Mauao Awaiti Viewing Platform - Building Consent No. BC330131 - Ground Confirmation Statement

Site Visit Report N° 001

Project: Mauao Placemaking Project

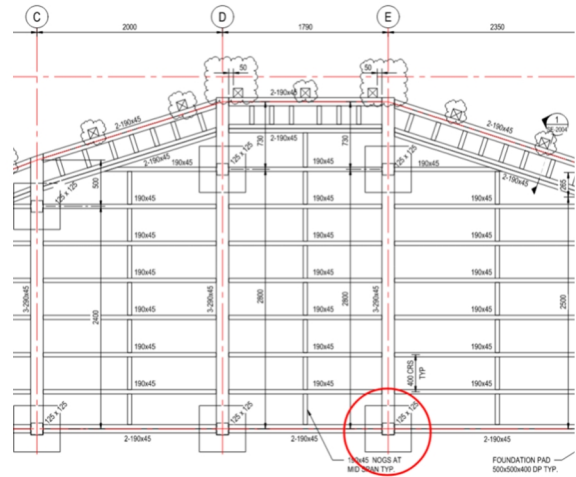
Comments made to/by contractor's representative: <ul style="list-style-type: none"> Contractor noted that the hole that was only 600mm deep (along grid D) could not be dug any deeper due to there being rock below. Contractor proposed to chemset reinforcing into the rock to mitigate lateral forces and therefore slips. Contractor noted that the soil material below the top soil was very hard and difficult to excavate Beca noted that subgrade testing was required as per note 3.0 on SE-2001 on the structural drawings. Beca noted that a construction methodology was required to be send to the engineer as per 1. on SE-2001

- Contractor to provide subgrade testing
- Contractor to provide construction methodology

Figure 4: Hole only 600mm deep

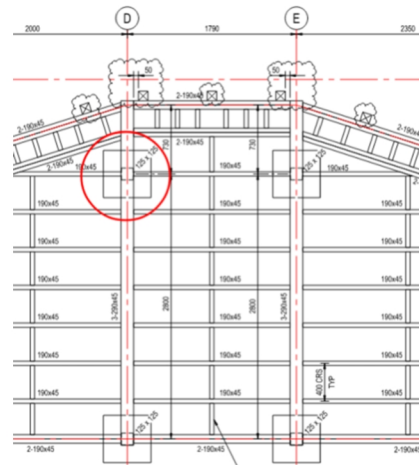
Beca has carried out a site visit during construction to inspect the ground conditions. A record of our site visit is included in Attachment 1. Dimensions and position of the foundations comply with the minimum requirements set out on drawing 4280807-SE-2005 Rev 0A except for one location on Grid D where excavation terminated 100mm above the target founding level. However, the ground conditions at this location where rock was encountered are more favourable than those assumed in design.
